Title: Relay Frame Structure – comments on 16mRelayFS-AHS - Alvarion

Document Number: C802.16m-08/265

Comment on Slide 6&7&8

Fig. xx Rx operation of RS1

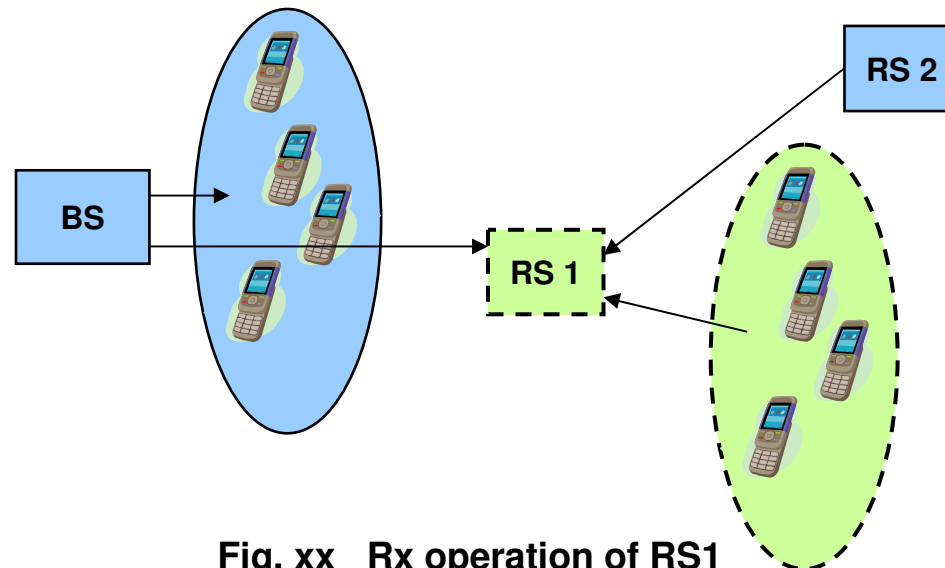
- Multiplexing Access and Relay Links in 16m Zone
 - Usage of UL and DL only is misleading
 - The criteria should be Relay Tx and Relay Rx
 - Better spectral efficiency, flexibility and interference management can be obtained if the multiplexing of 16m Access and Relay operation is done in frequency domain (FDM)
 - The existing text does not reflect 2 hops Relay operation
 - The TDD split creates 6 different Zones in MAC Frame, to be mapped to 6..8 sub-frames (depending on channel width and FFT size), creating a problem of spectral efficiency, resolution of allocations and not leaving time for BS Zones

In the DL 16m zone, inserted in BS DL sub-frame, the traffic is FDM multiplexed in different Zones based on Relay Rx or Tx operation. An example of the BS DL operation and Rx operation of RS1 ((BS->MS, BS->RS1, MS->RS1, RS2->RS1) is given in the next figure.

Fig. xz Relay operation in FDD mode (RS1-Rx, RS2-Tx)

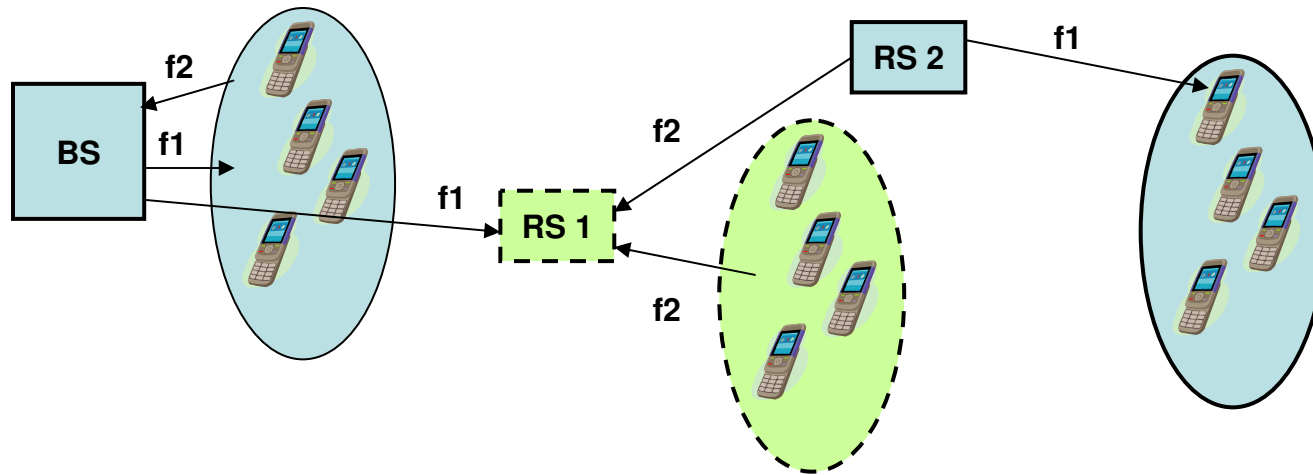
- No text was proposed in 16mRelayFS-AHS
- Alvarion's proposed text (according to principles in C802.16m-08/261):

The RS is the focal point for grouping the Tx and Rx activities, which are TDM multiplexed. The following figures show the traffic directions and the used frequencies for two hops, in each of the Relay Tx and Rx time intervals.
